**PLANNED UNIT DEVELOPMENT
& SUBDIVISION STAFF REPORT****Date: November 6, 2014****DEVELOPMENT NAME**

C.J. Small Subdivision No. 2

Planned Unit Development Approval to allow shared
parking and multiple buildings on a single building site and Subdivision Approval to create 2
legal lots of record.

SITE PLAN

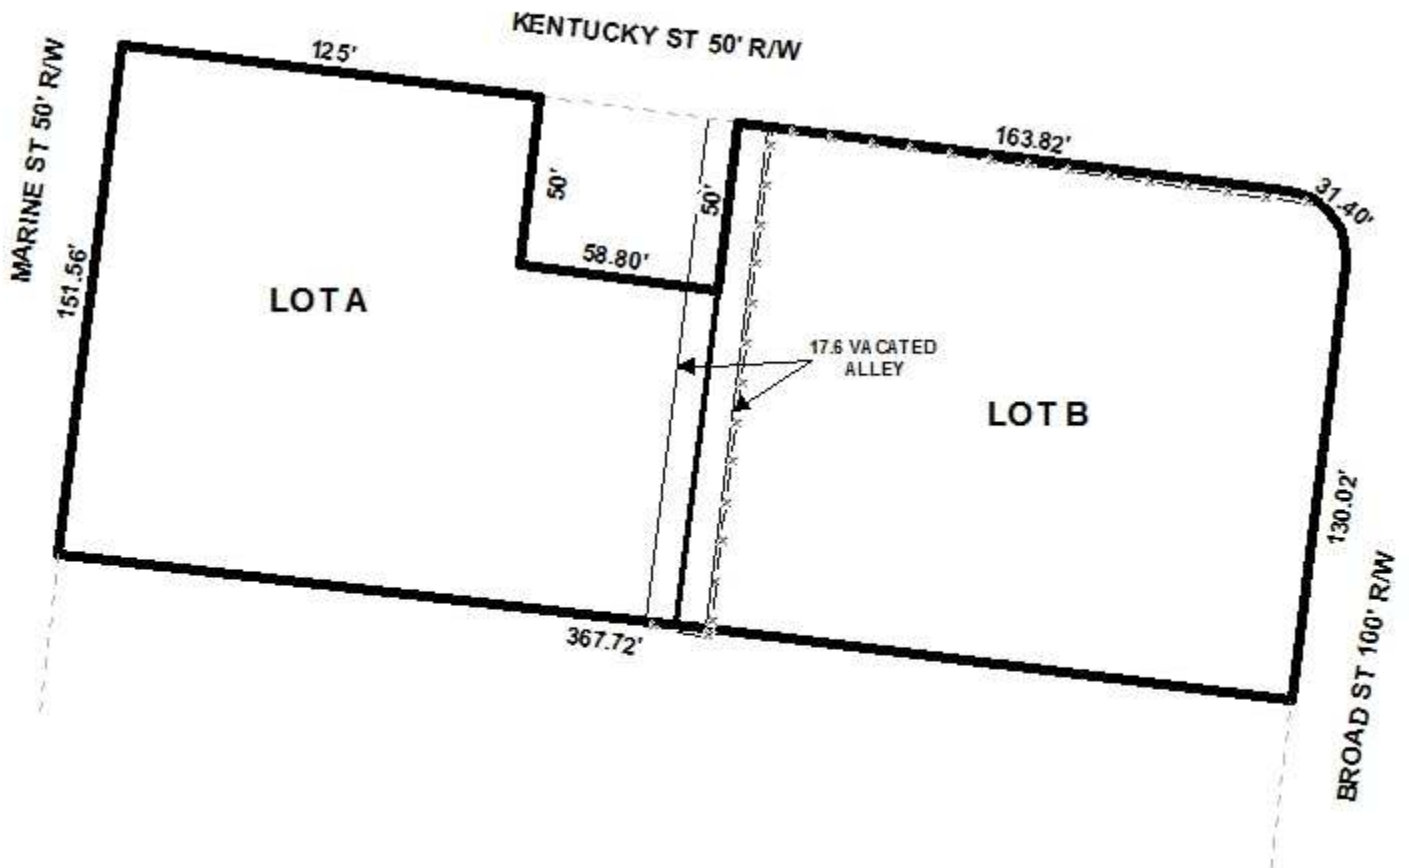
In accordance to the Subdivision Regulations, both proposed lots appear to exceed the minimum size requirements. The lot sizes in square feet and acres are illustrated on the preliminary plat and should be retained on the Final Plat. The 25' minimum building setback line is not depicted, but should be illustrated on a revised site plan and Final Plat, if approved.

There does not appear to be any proposed new parking areas and the proposed 24' wide asphalt drive appears compliant in regards to travel aisle width.

Sidewalks are shown on the site plan; however, there is no dumpster depicted. The site plan should be revised to illustrate a dumpster in compliance with Section 64-4.D.9. of the Zoning Ordinance, to include a connection to sanitary sewer, or a note should be placed on the site plan stating garbage collection will be via curb-side pick up.

Landscaping notes, including credit trees, are included on the site plan and would appear to comply with Section 64-4.E. of the Zoning Ordinance regarding tree and landscaping requirements. However, it should be pointed out that the 3 required perimeter trees appear to be located within the frontage.

The 38 existing parking spaces would appear to be sufficient with regards to the building's proposed size and number of seats; however, the site plan does not appear to illustrate any accessible parking spaces or routes and, although the Planning Section does not enforce accessible parking or ADA, certain aspects of ADA do impact site design. As such, the revised site plan and building plans should depict a compliant number of accessible spaces and design compliance with the requirements of the ADA, in accordance to the applicable building code section 1106 (and 2010 ADA Standards for Accessible Design).

The applicant should also be aware that any new lighting on the site will have to comply with the requirements of Sections 64-4.A.2., 64-6.A.3.c., and 64-6.A.8. of the Zoning Ordinance. It appears that there is an unshielded floodlight mounted on a utility pole in the Marine Street right-of-way, shining into the parking area: this existing flood light does not comply with the previous lighting requirements of the Zoning Ordinance in that it likely casts light onto the adjacent residence to the south. Existing lighting should be modified with shields and/or redirection so as to not shine onto adjacent residential property. Any new lighting must comply with the requirements of the Zoning Ordinance.

The PUD site plan illustrates 3 proposed trees adjacent to the previously mentioned utility pole and within the first 15' of the front 25' setback. Any tree planted within the first 15' of the front 25' setback must be Live Oak and any tree planted within 15 horizontal feet from overhead utilities must also be Live Oak if overstory or Crape Myrtle if understory. As such, the site plan should be revised, as necessary, to illustrate full compliance with the tree and landscaping requirements of the Zoning Ordinance. A dumpster appears to be located in this landscaped area: the dumpster must be moved to a compliant location, with a compliant enclosure.

- 2) Provision of a compliant tree and landscape plan at time of any land disturbance request for the facility;*
- 3) Revision of the site plan to illustrate full compliance with the dumpster requirements in Section 64-4.D.9. of the Zoning Ordinance for the existing dumpster or the placement of a note stating garbage collection will be via curb-side pick up;*

- 4) Revision of the site plan to illustrate to depict a compliant number of accessible spaces adjacent to the proposed facility, and design compliance with the requirements of the ADA, in accordance to the applicable building code section 1106 (and 2010 ADA Standards for Accessible Design);*

- 5) Modification of existing site lighting, through redirection and/or shielding, to not shine onto any adjacent residences;*
- 6) Placement of a note on the revised site plan stating: (All new lighting on the site to comply with the requirements of Sections 64-4.A.2., 64-6.A.3.c., and 64-6.A.8. of the Zoning Ordinance);*
